Item ID: D412-664-203TRN

Item Name: Crosstube Turning Detail

DART AEROSPACE LTD		Work Order:	113976
Description: Crosstube Assembly (412 High Aft)		Part Number:	D412-664-243
Inspection Dwg: D412-664-243 Rev: E		Page 1 of 2

DRAWING NO. D412-664-243	TITLE CROSSTUBE ASS'Y (412 HI AFT)	REV. E	DART AEROSPACE LTD ENGINEERING ORDER		D.E.O. NO. D412-664-243-E-2	SHEET NO. SHEET 1 OF 1	SCALE NTS
DRAWN <i>qp</i>	CHECKED <i>ASS</i>	MFG. APPR. <i>ER</i>	APPROVED <i>MP</i>		DE APPR. <i>#</i>		
DATE 11.09.07	DATE 11.09.19	DATE 11.09.19	DATE 11.09.19		DATE 11.09.19

D412-664-603
BENT TUBE

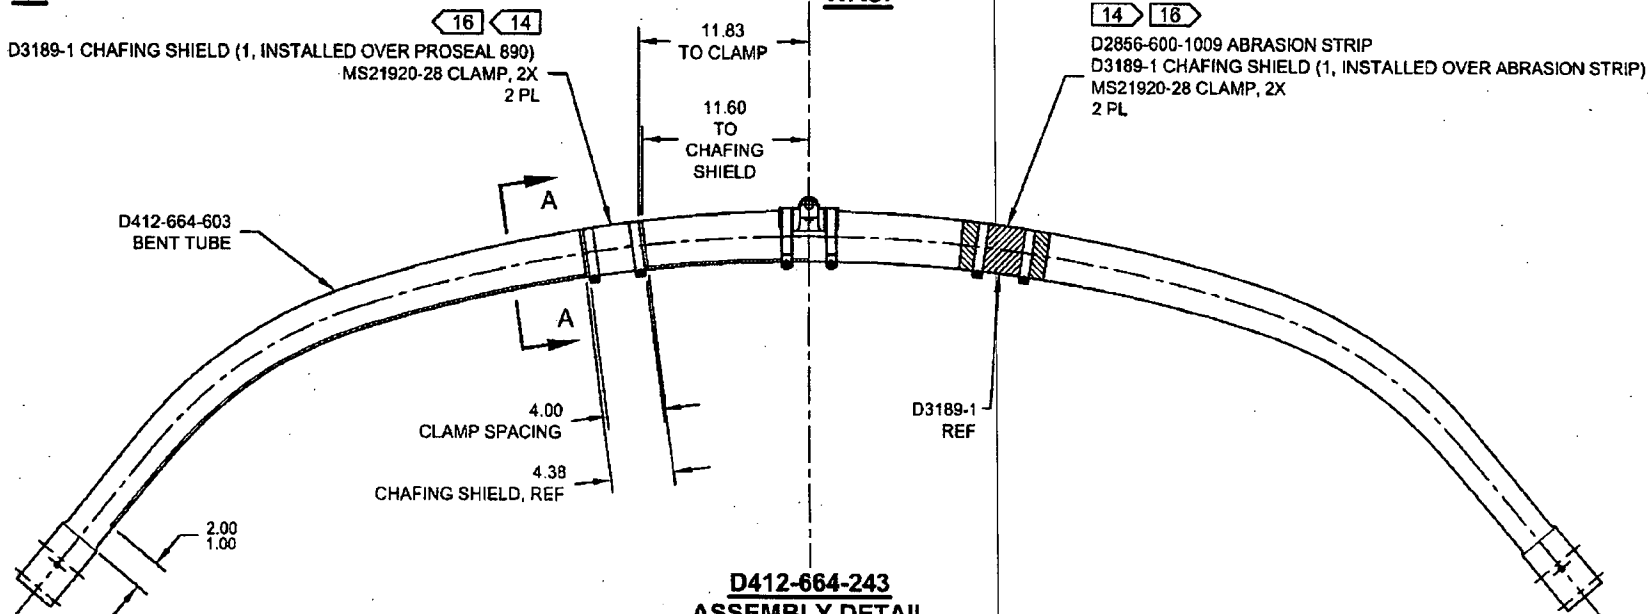
REMOVED ABRASION STRIP IN FAVOR OF A THIN LAYER OF PROSEAL 890. UPDATE INSTALLATION OF CHAFING SHIELDS AND REDUCE TORQUE TO 40-50 IN-LBS. THIS ENGINEERING ORDER SUPERCEDES DEO D412-664-243-E-1.

NOTES 2, 14, AND 16 ON SHEET 1 ARE AMENDED AS FOLLOWS:

IS:

D3189-1 CHAFING SHIELD (1, INSTALLED OVER PROSEAL 890)
MS21920-28 CLAMP, 2X
2 PL

WAS:

D2856-600-1009 ABRASION STRIP
D3189-1 CHAFING SHIELD (1, INSTALLED OVER ABRASION STRIP)
MS21920-28 CLAMP, 2X
2 PL

MASK AREA PRIOR TO PAINTING AND
APPLY CLEAR COAT AFTER PAINTING

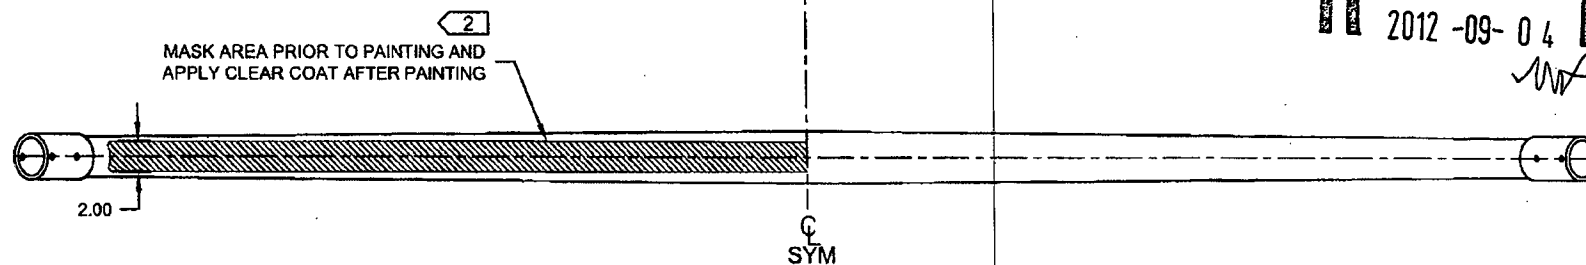
- 2) FINISH: CHEMICAL CONVERSION COAT PER DART QSI 005 4.1
PRIME INSIDE AND OUTSIDE PER DART QSI 005 4.2
MASK UNDERSIDE OF CROSSTUBE AS SHOWN (HATCHED AREA)
PAINT OUTSIDE PER DART QSI 005 4.2
AFTER PAINTING, APPLY CLEAR COAT ON HATCHED AREA
- 14) APPLY A THIN COAT OF PROSEAL 890 ON INSIDE CONCAVE SURFACE OF D3189-1 CHAFING SHIELD AND LET CURE PER MANUFACTURER'S INSTRUCTIONS. INSTALL PROSEALED D3189-1 CHAFING SHIELD ONTO CROSSTUBE BY APPLYING A THIN COAT OF PROSEAL 890 ONTO CROSSTUBE. BE SURE TO ELIMINATE ANY AIR GAPS.
- 16) TORQUE CLAMPS ON D2896-1 SUPPORT 80 TO 100 IN-LB. **TORQUE CLAMPS ON D3189-1 CHAFING SHIELD 40 TO 50 IN-LB.** ENSURE AT LEAST 1.5 THREADS SHOWING IN SAFETY AND THAT NUT HAS NOT BOTTOMED-OUT AFTER TORQUING.
